IFB No. **18-29 McIntosh Reroofing, Mechanical Upgrades and Boiler Replacement**

RE: **ADDENDUM NO. 1**

McIntosh Re-roofing / Boiler Replacement & Mechanical Upgrades Project

Project Number: C1868

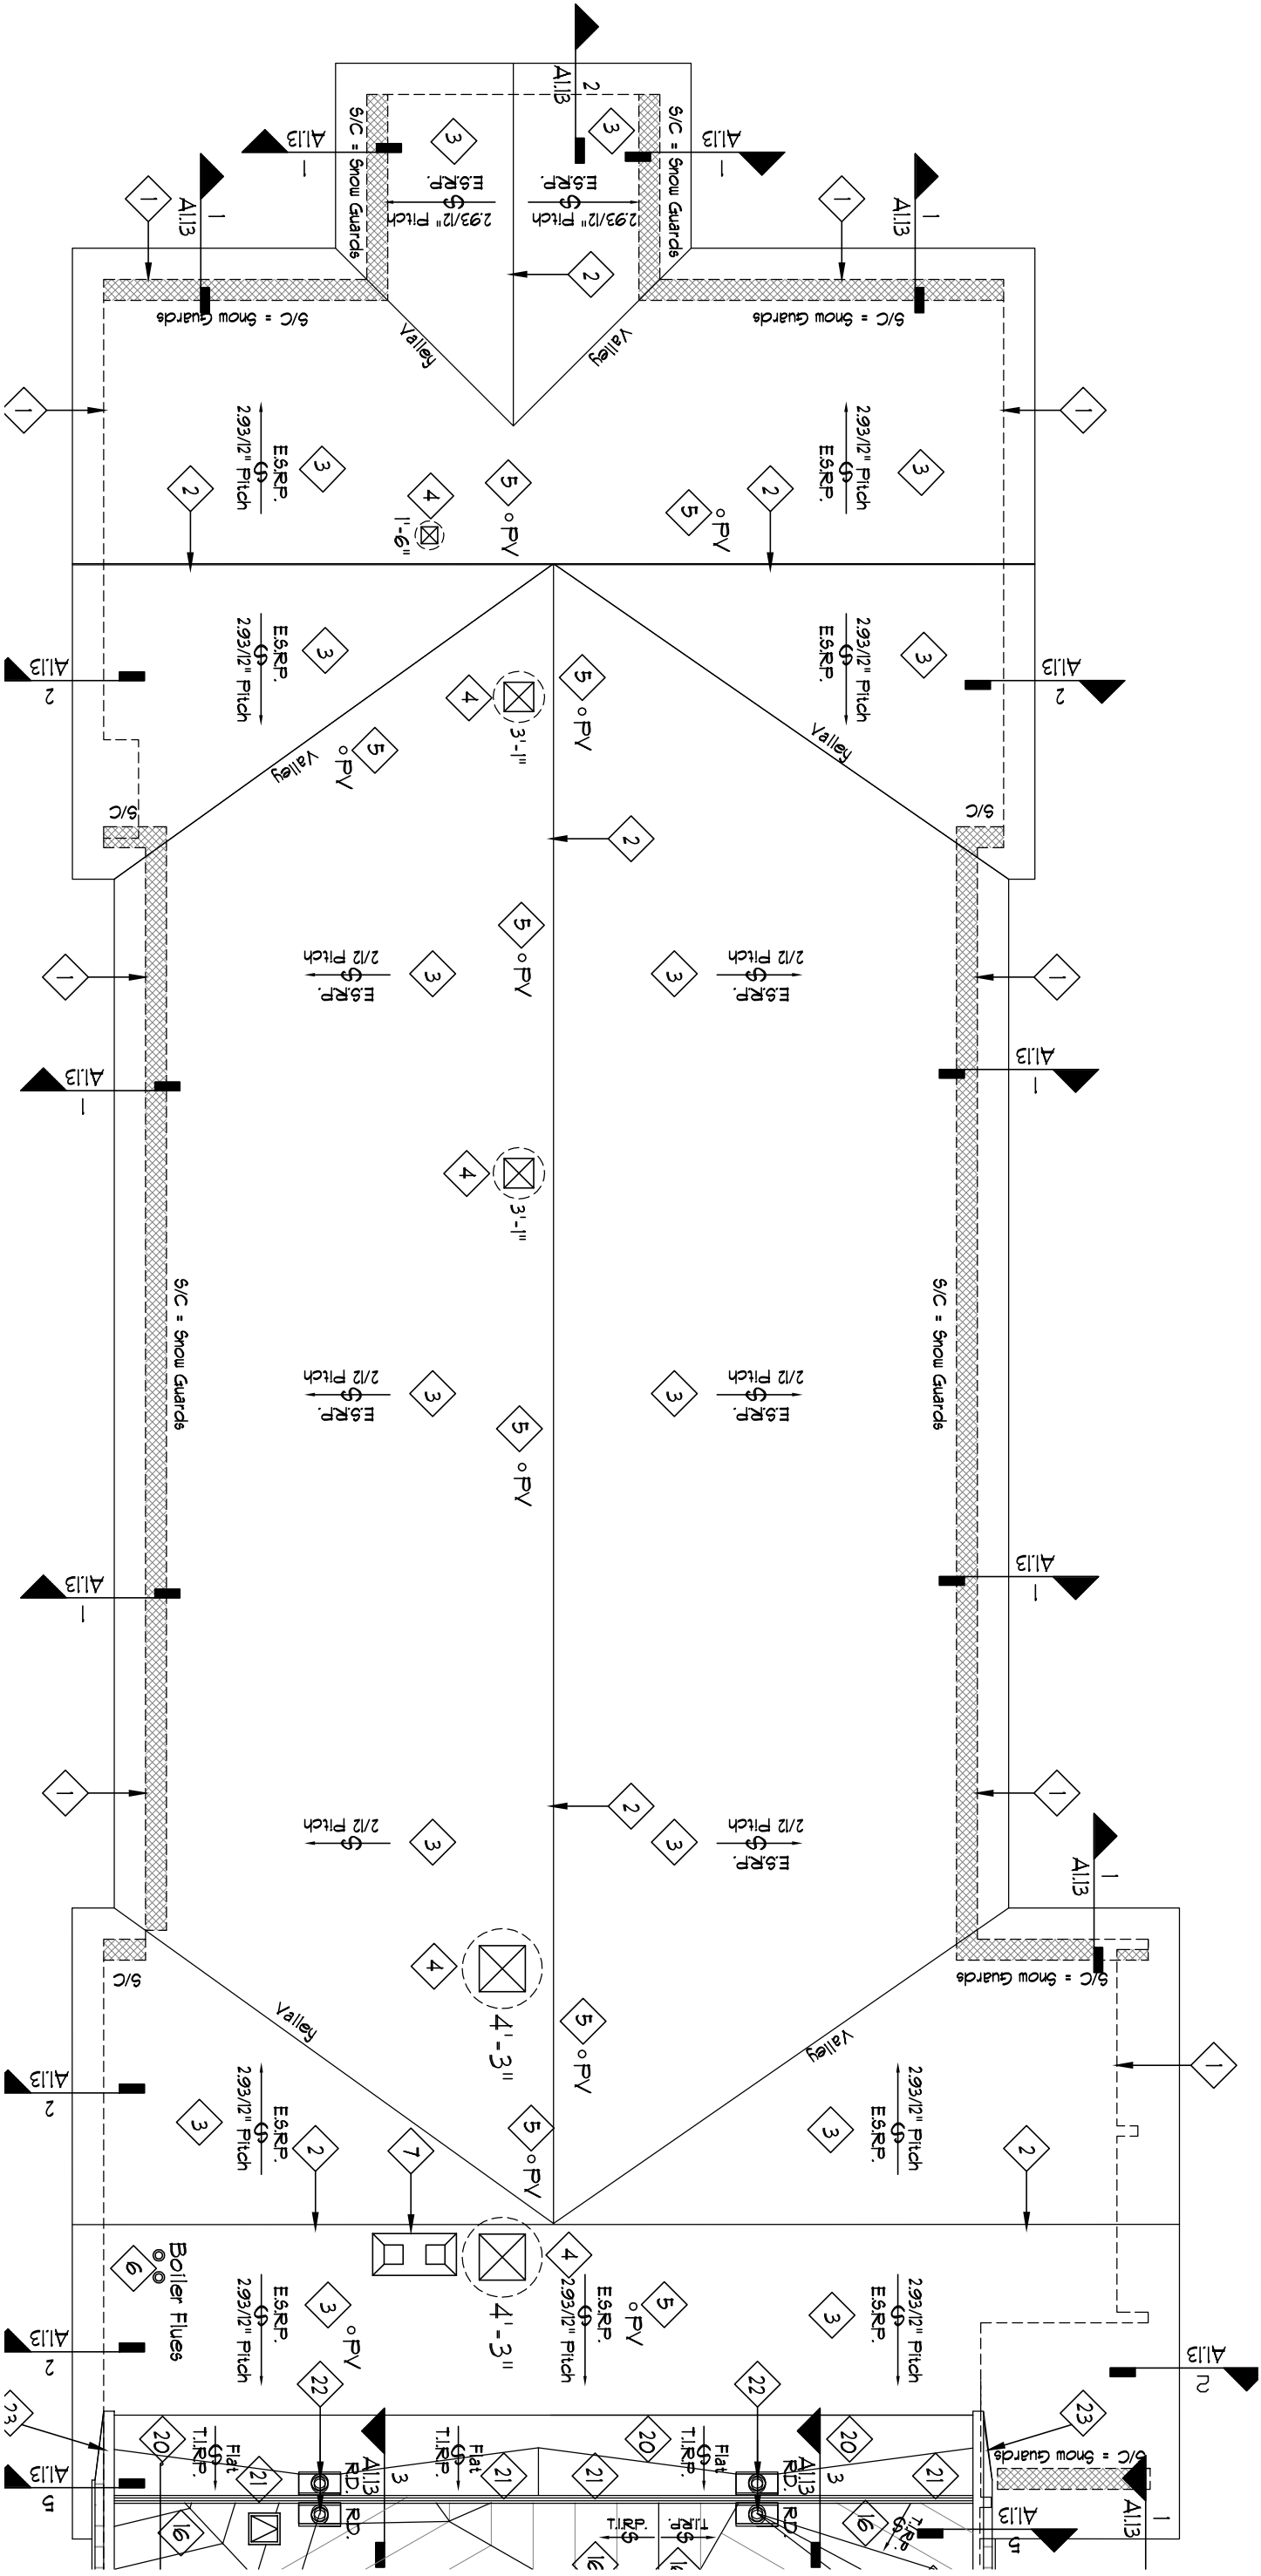
- A. Design Requirements for Wall Systems:
 - 1. Provide two rows of staggered guards, two feet on center, starting from exterior building wall line back over roof plane (See Plan)
 - 2. System Design: Snow guard system as designed by the manufacturer shall be a complete system. All components of the system shall be supplied by the same manufacturer.
 - 3. Accessories and Fasteners: Accessories and fasteners shall be capable of resisting the design forces in accordance with local building code.
